STAFF RECOMMENDATION
1404 North 14th Street
December 20, 2017

Application: New construction - addition
District: Eastwood Neighborhood Conservation Zoning Overlay
Council District: 06
Map and Parcel Number: 07214017500
Applicant: Daniel Reeder
Project Lead: paul.hoffman@nashville.gov

Description of Project: Application to construct a rear addition to a contributing building.

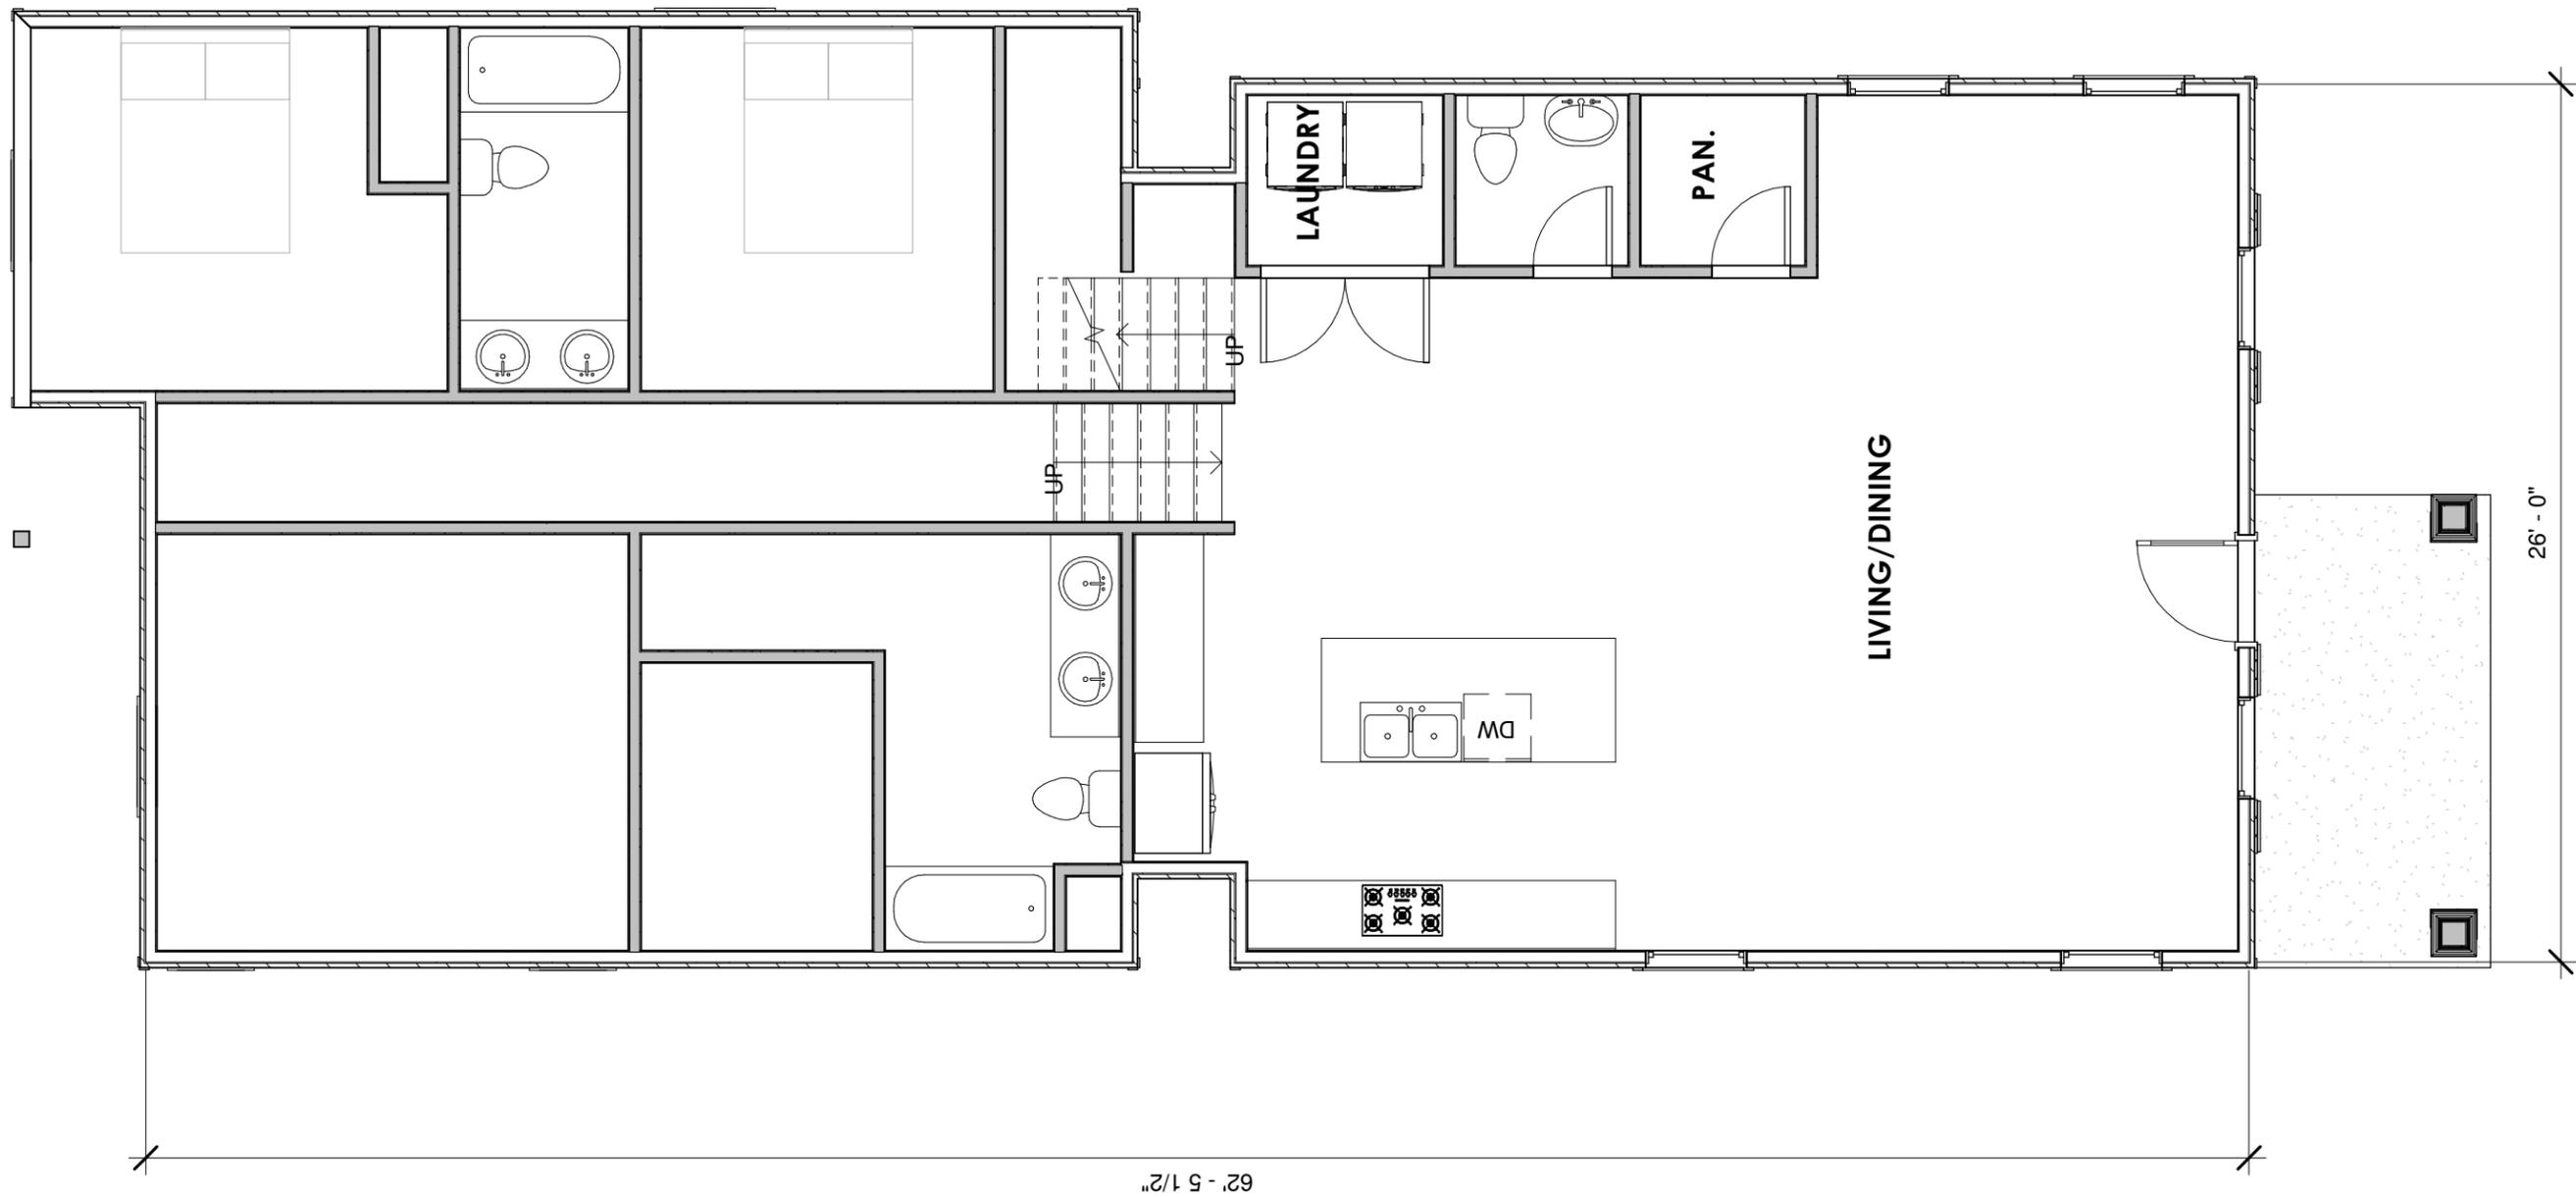
Appurtenances & Utilities: No changes to the site's appurtenances were indicated on the drawings. The location of the HVAC and other utilities was also not noted. Staff

recommends that the HVAC be located on the rear façade, or on a side façade beyond the midpoint of the house. The project meets section II.B.1. i.

1. Existing window openings are maintained;
2. Staff approve the roof color, windows and doors prior to purchase and installation; and,
3. HVAC be located on the rear façade, or on a side façade past the midpoint of the house.
